LRD Amendment App (Blocks C, DE, L and J) at St. Vincents Hospital Fairview

Block DE Proposed South Elevation

SCALE @A1: 1:200	ISSUED: 16/01/26
DRAWN BY: MJ	CHECKED BY: Checker
PROJECT NO.: 20006	PROJECT ARCHITECT: PAUL BARRY
DRAWING NO.: **SVRD-STW-DE-ZZ-DR-A-024204**	REVISION: **P01**

1 SOUTH ELEVATION - PROPOSED
SCALE: 1 : 200

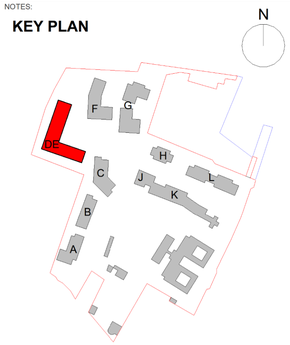
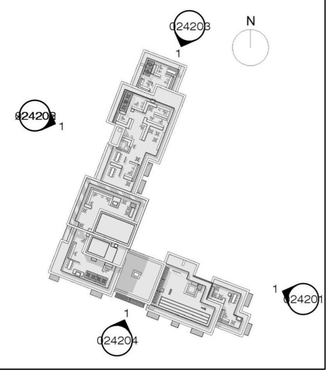
1. Common Areas amended to new units with associated new balconies and revised elevation. Brise Soleil on South and East Elevation to be omitted.
2. Additional Doors to enlarged ESB Substation and door removed from Energy Centre
3. Windows amended to match amended unit at Ground Floor level.
4. Elevational Change
